**Landscape Review Committee**  
**Community Development Center, 231 NE 5<sup>th</sup> Street**  
**July 18, 2018**  
**12:00 PM**

## **EXHIBIT 1 - STAFF REPORT**

**DATE:** July 18, 2018  
**TO:** McMinnville Landscape Review Committee  
**FROM:** Jamie Fleckenstein, Associate Planner  
**SUBJECT:** Agenda Item 4A: L 18-18

An application for a landscape plan for a new commercial shell building (L 18-18) to be reviewed by the Landscape Review Committee.

**SITE RESTORATION & LANDSCAPE PLAN**  
SCALE: 1" = 10'

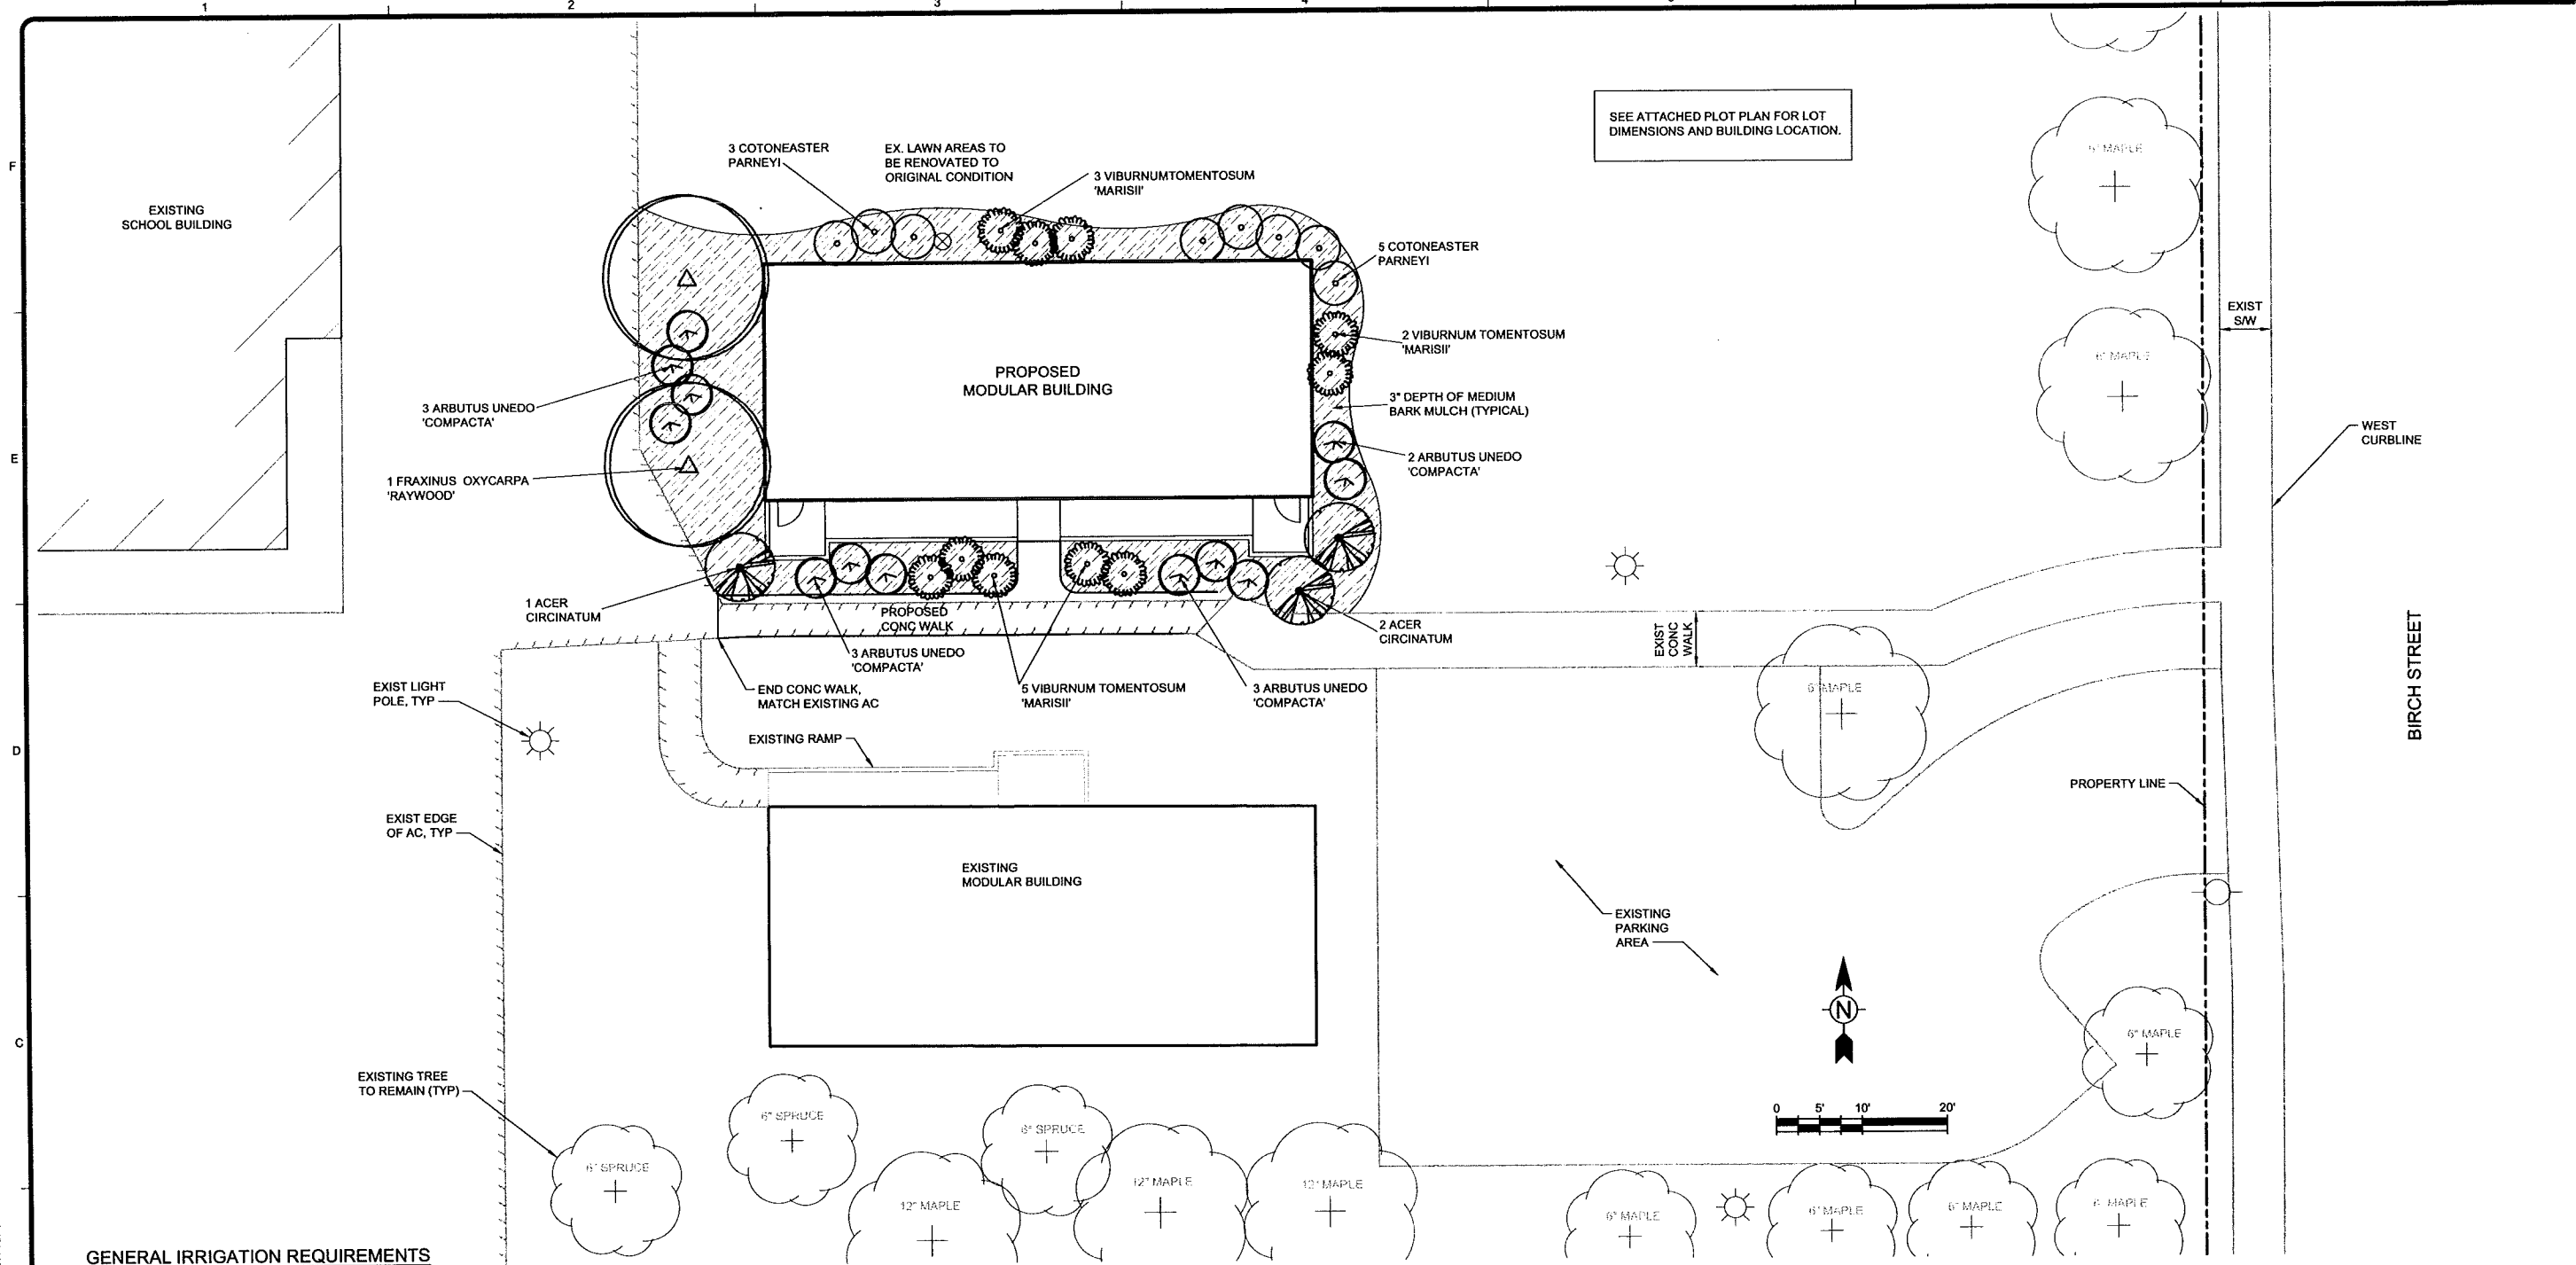
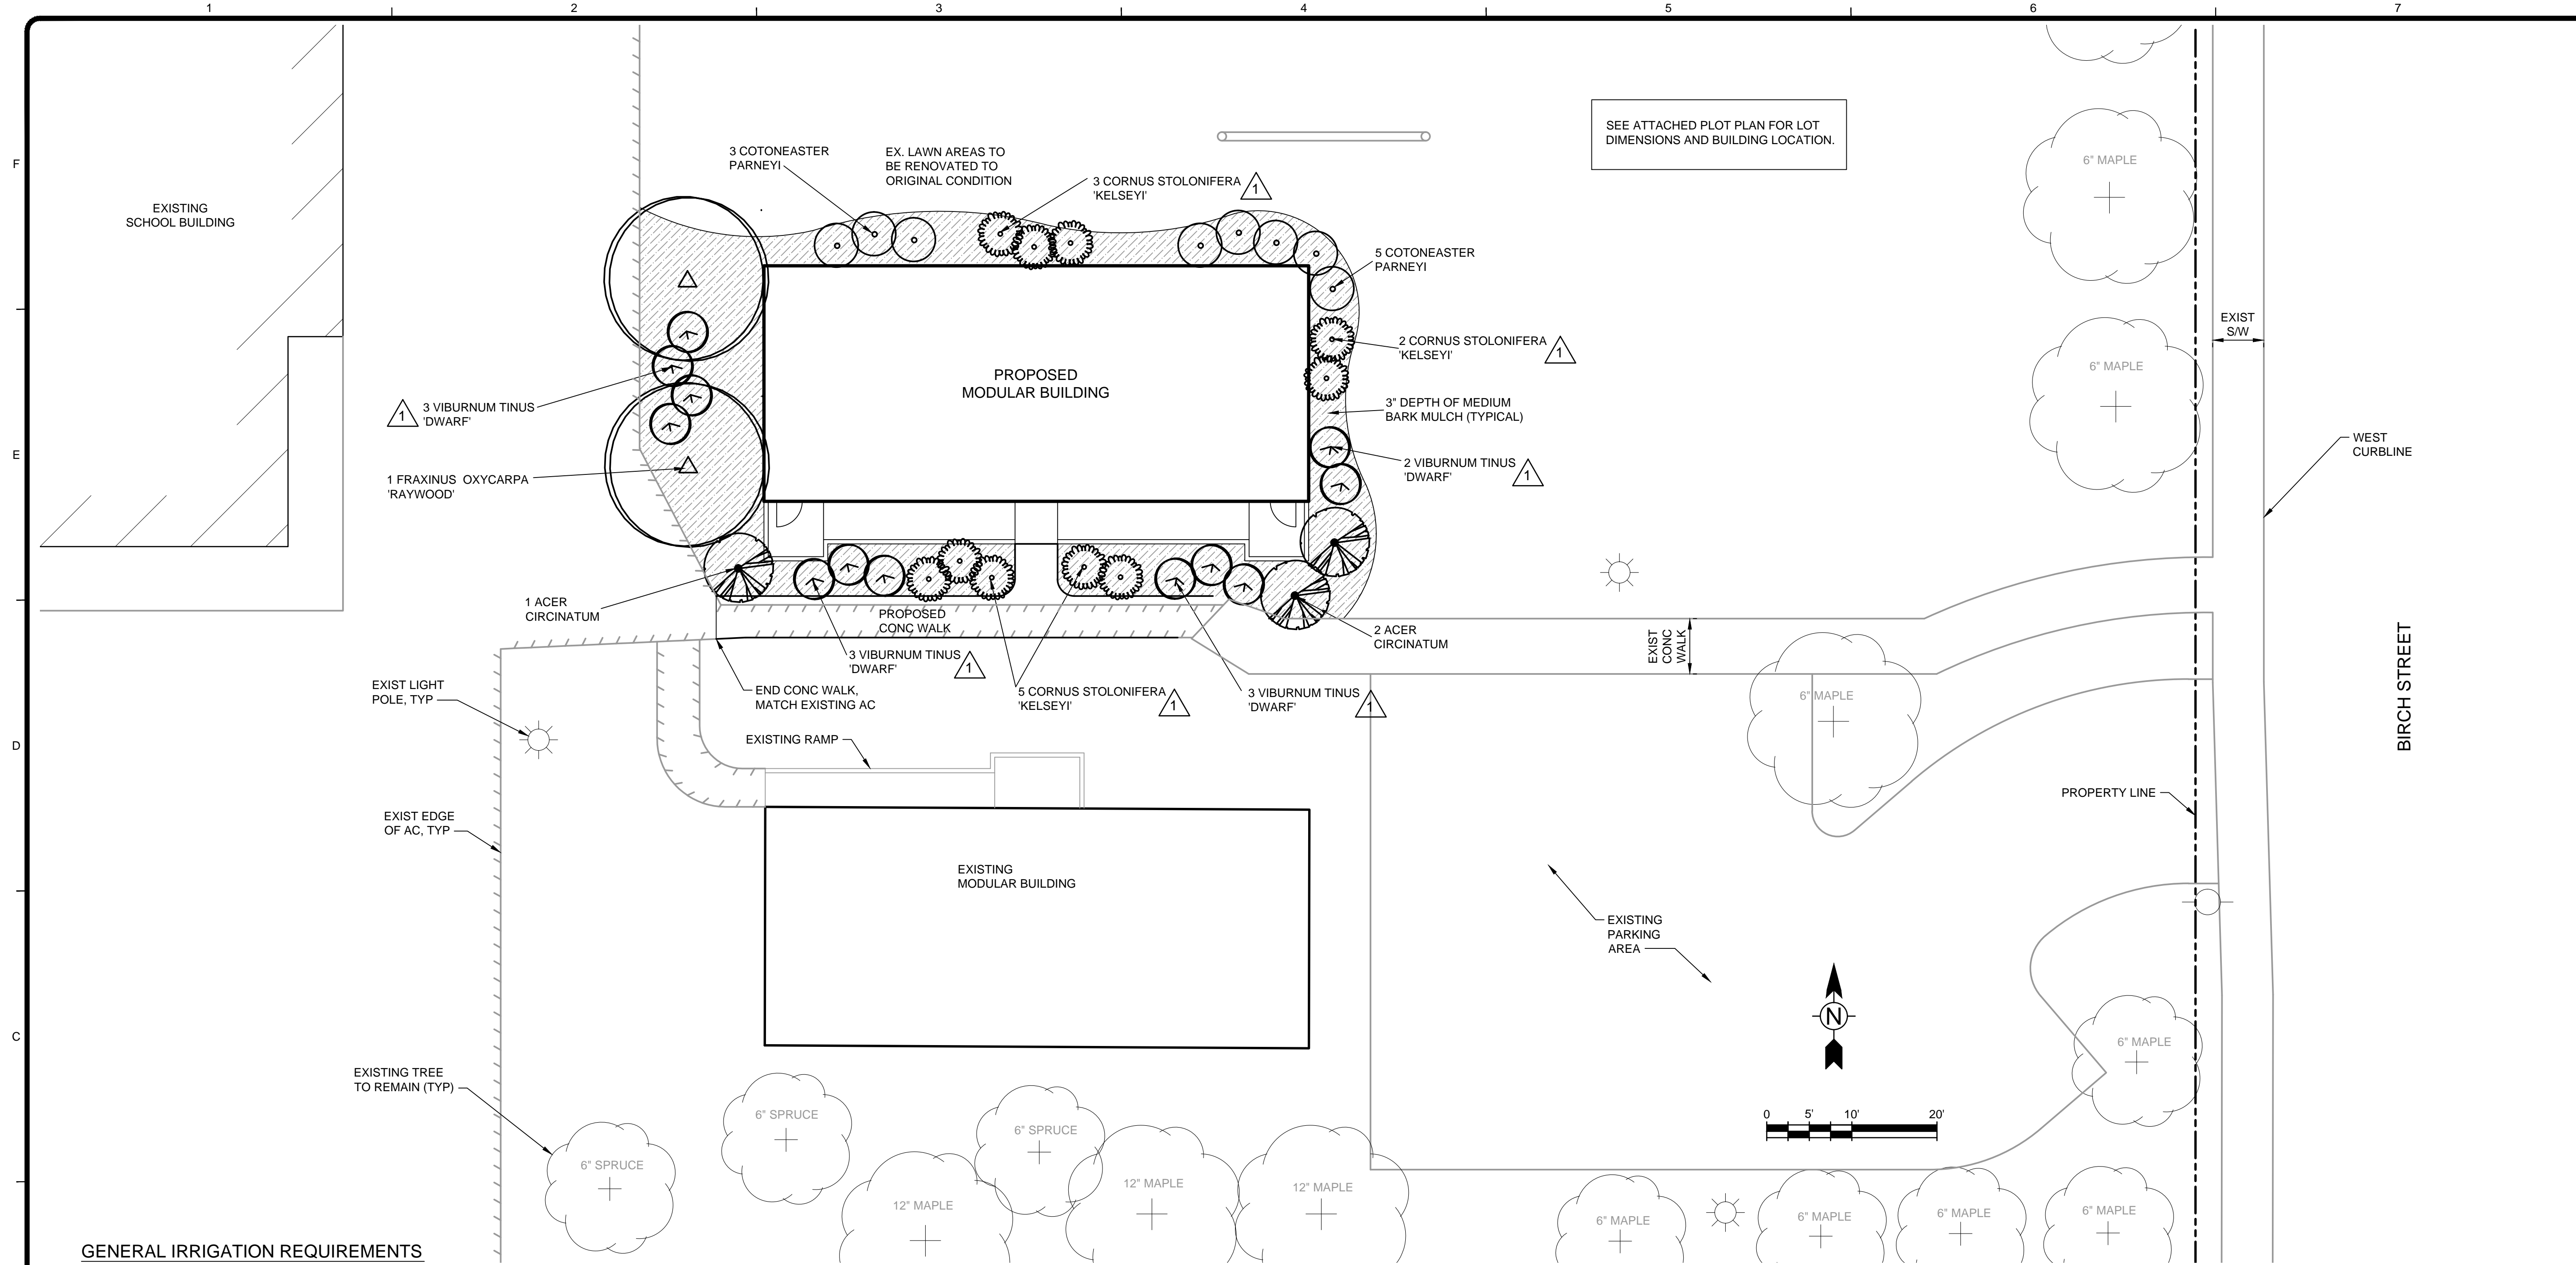
The subject site is surrounded by single family residences on all sides. The area of proposed development is located in the south-eastern quadrant of the subject site. Directly north of the development site are single family homes whose rear yards abut the playfield where the development is proposed. These homes all have fences between their yards and the school property. East of the development site, across NW Birch Street, are single family homes that face the proposed development. A line of existing trees provides a buffer and screen from the school property. South of the development site is an existing modular classroom building, and two single family homes. A fence and a line of small trees provides a buffer and screen from the school property. Memorial Elementary School sits immediately west of the proposed development site. The perimeter of the adjacent modular classroom building is planted with a mix of medium sized shrubs, and small and medium sized trees.

The landscape plan proposes planting around the perimeter of the modular classroom building and repair of grass areas of the playfield damaged by construction. On the west side of the proposed modular classroom, the applicant is proposing two large deciduous shade trees (*Fraxinus oxycarpa* 'Raywood'/Raywood Ash) and 4 evergreen shrubs (*Viburnum tinus* 'Dwarf'/Dwarf Laurustinus). Raywood Ash grow to approximately 70 feet tall, and Dwarf Laurustinus will grow to 5-6 feet tall and wide in maturity. Along the north and east sides of the proposed modular classroom, the applicant is proposing alternating groupings of evergreen shrubs (*Cotoneaster parneyi*/Parney Cotoneaster) and deciduous shrubs (*Cornus stolonifera* 'Kelseyii'/Kelsey's Redtwig Dogwood). Parney Cotoneaster will grow to 8-10 feet tall and 10 feet wide in maturity. Kelsey's Redtwig Dogwood will reach 2-3 feet tall and wide in maturity. Along the south side of the proposed modular classroom, the applicant is proposing groupings of Dwarf Laurustinus and Kelsey's Redtwig Dogwood, and three small trees (*Acer circinatum*/Vine Maple). Vine Maples will reach 25-30 feet in height.

The proposed use will be screened from adjacent single family homes by the proposed landscaping around the perimeter of the modular classroom building, and by the existing landscape elements on the property but outside the area of development (fence along north property line, trees along W. Birch Street, and landscaping adjacent to SF homes to the south). A close up view of this area, and the vegetation that exists along the property line, can be seen below:

The landscape plan includes general irrigation requirements for a permanent irrigation system to be designed and built by the installing contractor. Staff is recommending a condition of approval be included to require that adequate watering facilities are provided, and also that all landscaping approved by the Landscape Review Committee be maintained, including necessary watering, weeding, pruning, mowing, and replacement.

1. That the applicant shall install landscaping as shown on the landscape plan dated July 2, 2018.
2. That all new landscape planters and lawn areas shall have suitable watering facilities or an irrigation system.

3. That the applicant shall maintain proper clearances around the existing and future water and electrical services that will be located on the site. Landscaping shall not be placed within four (4) feet of fire hydrants, within four (4) feet of water valves, within four (4) feet of vaults, within three (3) feet of the back or side of a transformer, or within one (1) foot of water meters. Minor adjustments in plant placement from the locations shown on the approved landscape plan are allowed if relocation is necessary to meet minimum clearances.
